CS Memorandum No. 1371

To: Distribution
From: Beverly Ward, CMB/Risk Management Assistant 
Date: March 5, 2013
Reference: Project No. M544.1, Contract No. CS-149
Task No. 1-8.02, Change Control
Subject: Configuration Management Board Meeting No. 114

CMB Meeting Minutes #114

SUBJECT: Configuration Management Board Meeting # 114 – Rev. No. 0

Pile Cap Layout Elevations

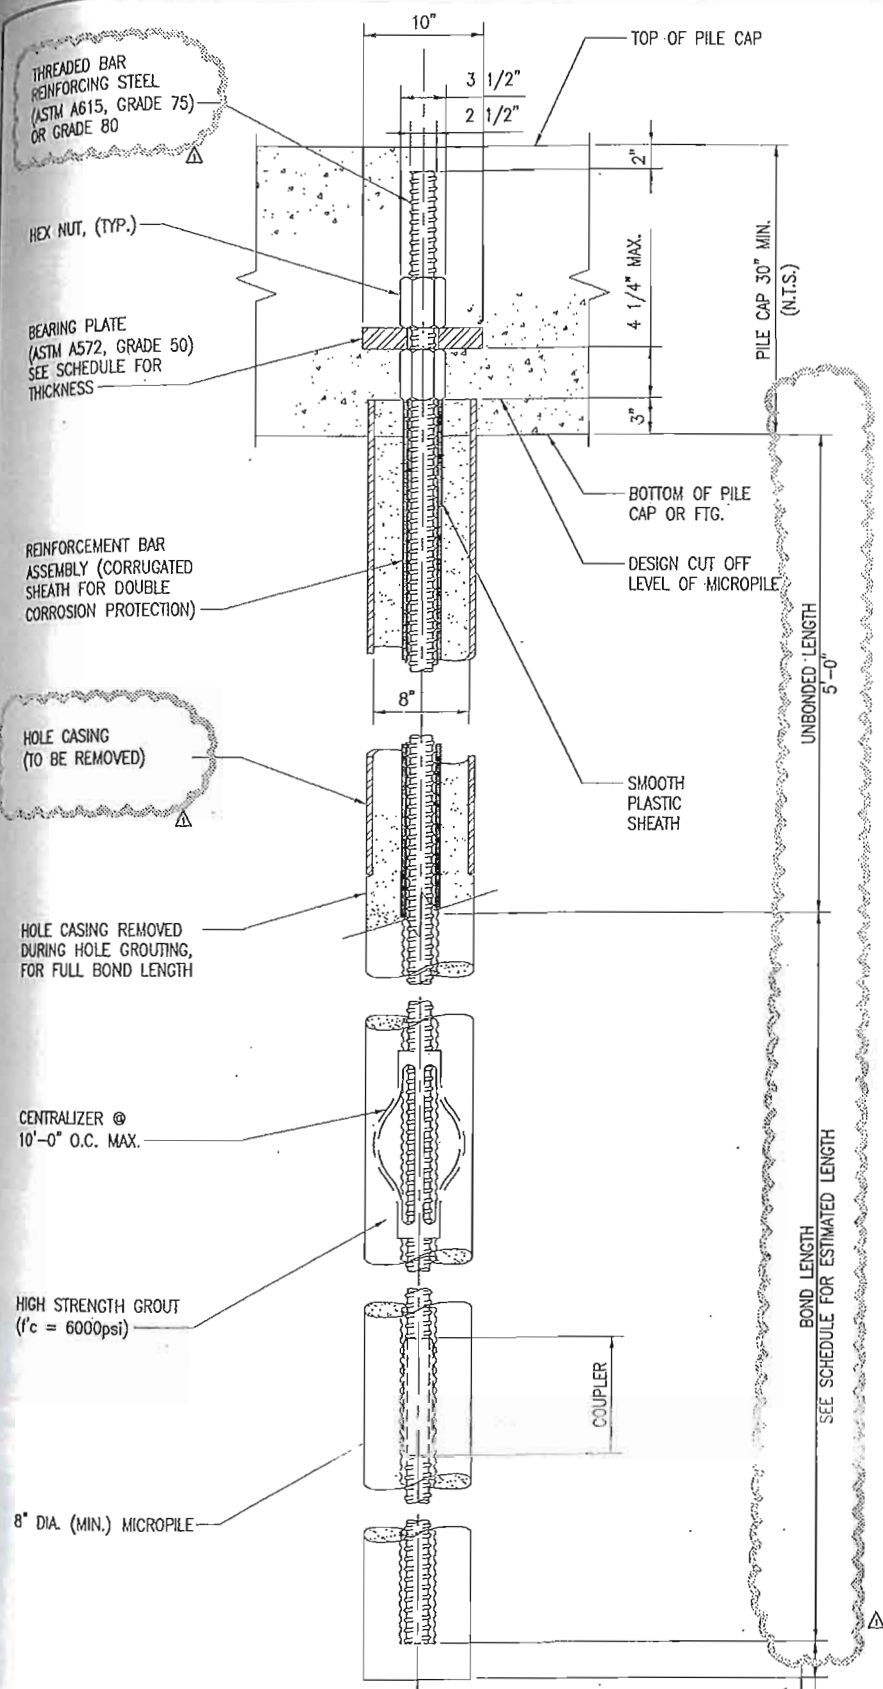
All clouded elevations shown on Elevation A-A are to top of pile cap footing.

Contractor shall confirm in field elevations shown shall not exceed max. heights indicated on detail 3/ SR-006 for various Wall Types.

Elevations shall be confirmed and coordinated to not interfere with proposed Joint Trench.

STRUCTURAL
MICROPILE DETAILS

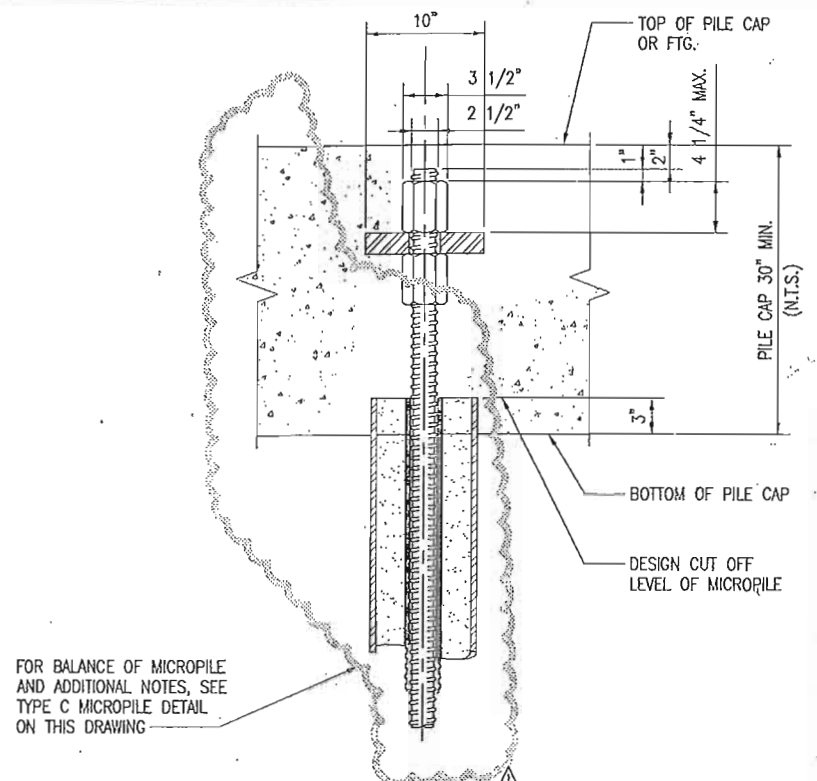
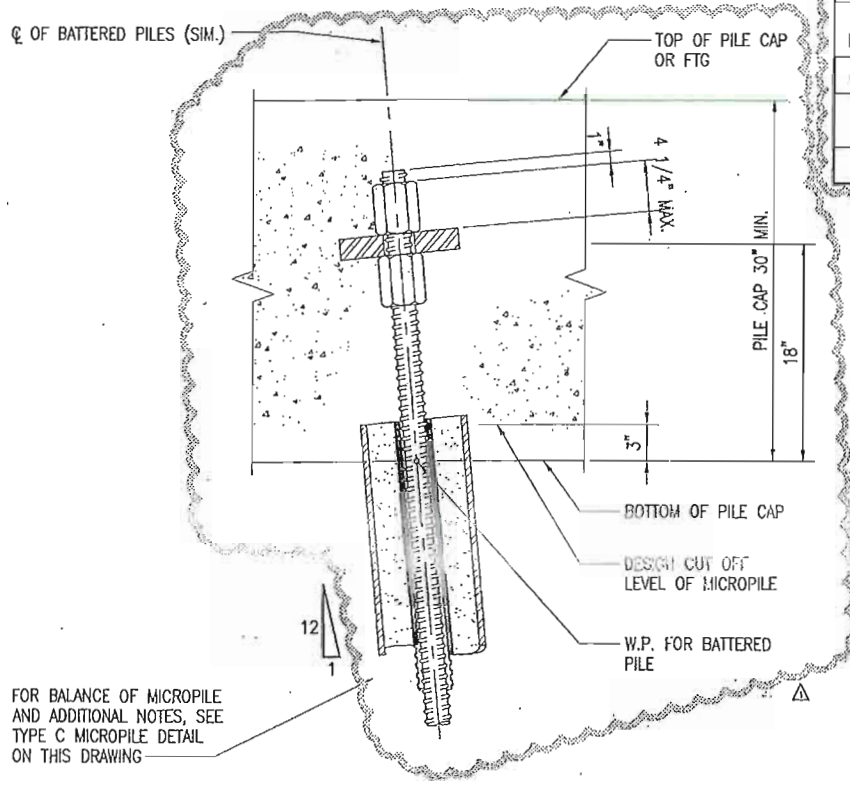
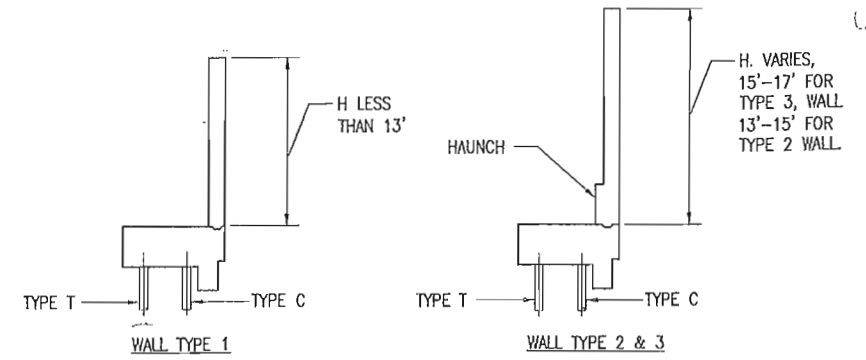
ITEM #	DISCUSSION	ACTION BY DUE DATE
5-	1252 – J. Funghi presented for discussion CN 1251 As built Structural Micropile Detail at 2 Stockton Street, which demonstrates the length of all the pin piles installed at 2 Stockton St. as 60ft long, rather than what is indicated in the CN1251 submittal. The issue raised concerns of the possibility that the micropiles may encroach on the tunnel. The CMB questioned who approved the 60ft length, who surveyed the offset and where is that data, also requesting a follow up action report of: 1) theoretical as built top of dirt elevation and 2) the actual data for top of rebar, to be provided Thursday morning 01/31.	ML/MB 01/31/13
6-	The Project Trend/Change Control Log version 01/30/13 was not viewed at this week's meeting. The log is updated to include most recent changes and trends for 1252. The log is attached for distribution with these meeting minutes.

Worse case is 62.5' Dwydag at 18.84' elevation with end of pile at -43.66' – Matt's spread sheet shows the 9 piles and how much they project into the tunnel.

Drill Tech's approved as noted Submittal 100.4, included the following comment from the Designer, "Max pile lengths not shown. Revise to include max pile lengths."

Type 3 Wall from Schedule A requires 55' bond length – which further supports why Drill Tech would use 62.5 foot bars.

No tension piles are battered at 2 Stockton.
